RAINIER CROSS-TOWN CONNECTOR FINAL ENVIRONMENTAL IMPACT REPORT MAY 2015

**RAINIER CROSS-TOWN CONNECTOR
FINAL ENVIRONMENTAL IMPACT REPORT**

2. Response to Comments..... 2-1

Figure 3.3 Construction Limits

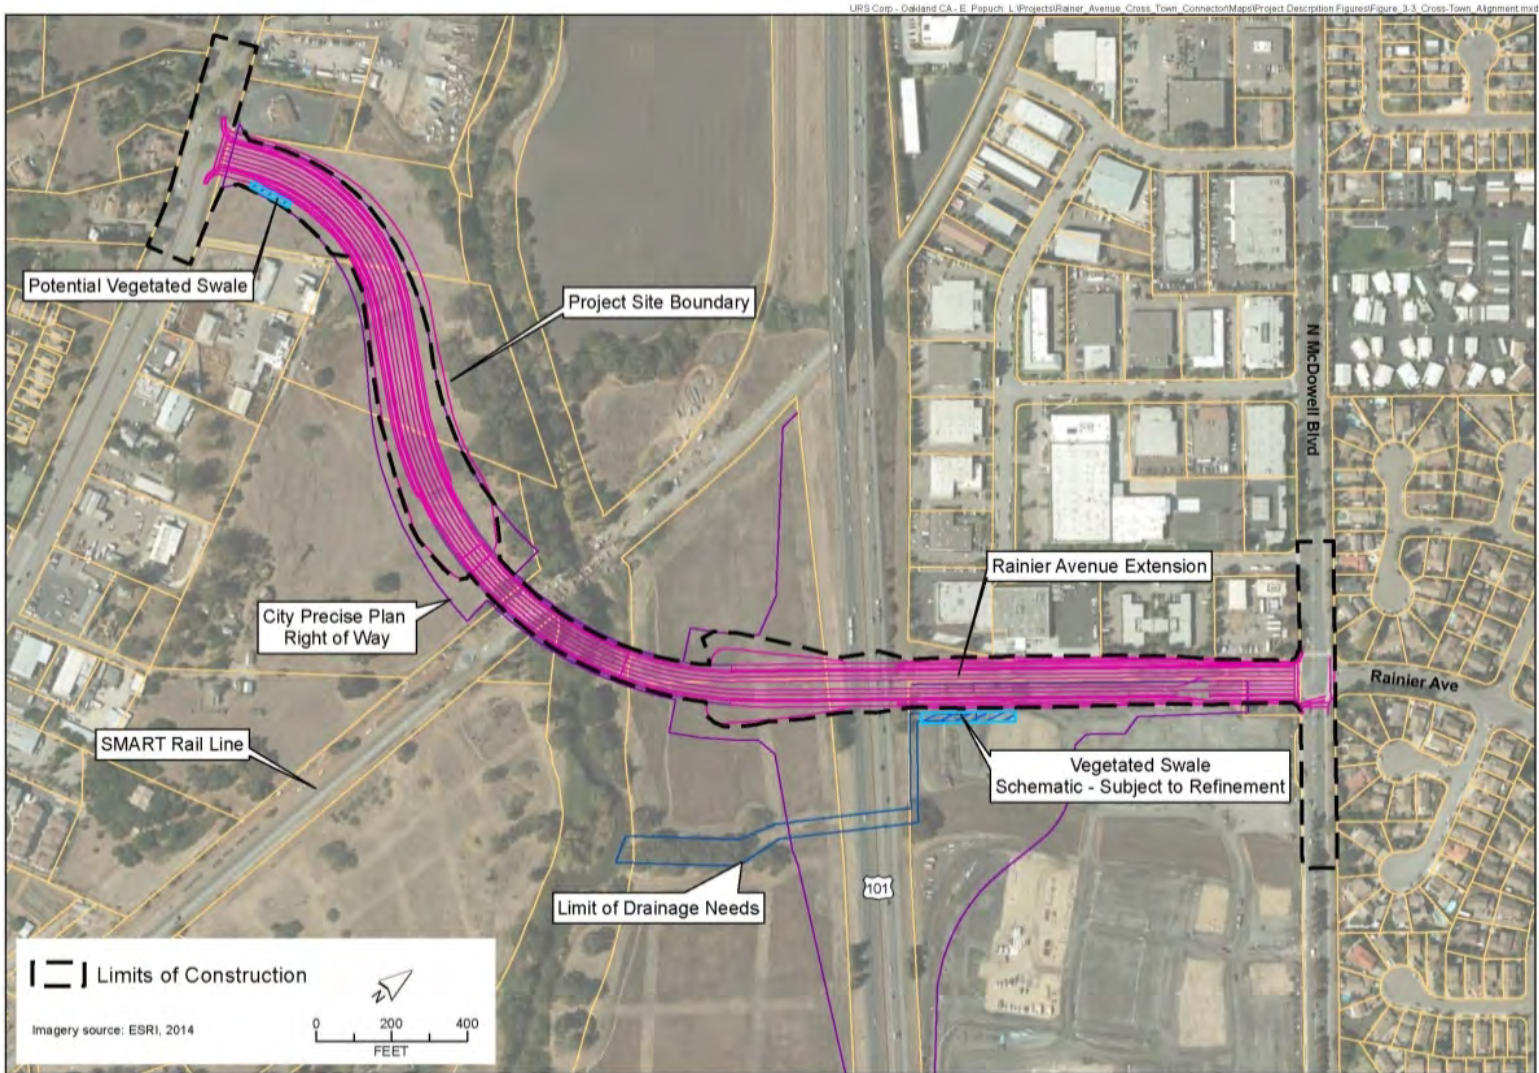
- The document states that a 508 foot bridge will be placed through the floodplain to span both the railroad and the Petaluma River floodplain. However, Figure 3.3 and Figure 3.6 show retaining walls across the floodplain. These Figures should be corrected to appropriately show a bridge across this area. 2-3

4 One of the other things that Caltrans culled
5 out, and that I had also noticed here, which I don't
6 remember being discussed at the Planning Commission,
7 was retaining walls being shown in Figure 3.3 in the
8 floodplain. And so I don't know -- retaining walls;
9 that can't happen in a floodplain. So I think that
10 really needs to be seriously addressed. I think that
11 this Draft EIR really underestimates the entire
12 flooding question.

Response 2-3 Commenter notes that Figure 3.3 and Figure 3.6 show retaining walls across the floodplain as opposed to the bridge. The figures were modified to remove the retaining wall labels.

Response Q12-23: The comment notes that retaining walls should not be put in the floodplain. As noted on Figure 3-3, the retaining walls would be a feature of the new bridge and would not impact flooding. Figure 3.3 was modified to exclude the retaining walls.

Page 3-8 Figure 3.3 was modified to remove the retaining wall.
